NUMBER 83

**BULLETIN**

**SUBJECT:** Tailskid Spring Attachment Reinforcement

**MODELS AFFECTED:** E2 and J2

SERVICE BULLETIN NO. 83

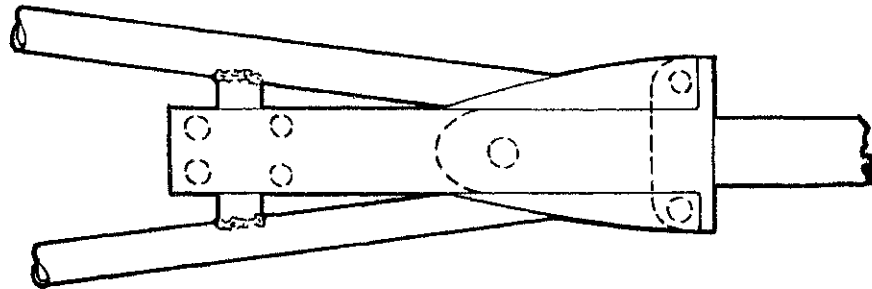
We have received a number of reports of failure of the tailspring attachment on the subject model airplanes, and at the suggestion of the Civil Aeronautics Administration, we have developed a reinforcing unit, part numbers 30882 and 30871, which may be bolted to the tailspring and fuselage structure. (See Sketch).

If your airplane is subject to hard landings, incident to student training, or if you are operating from a rough field, we recommend that this reinforcement be installed to prevent any possible failure of the tailspring attachment.
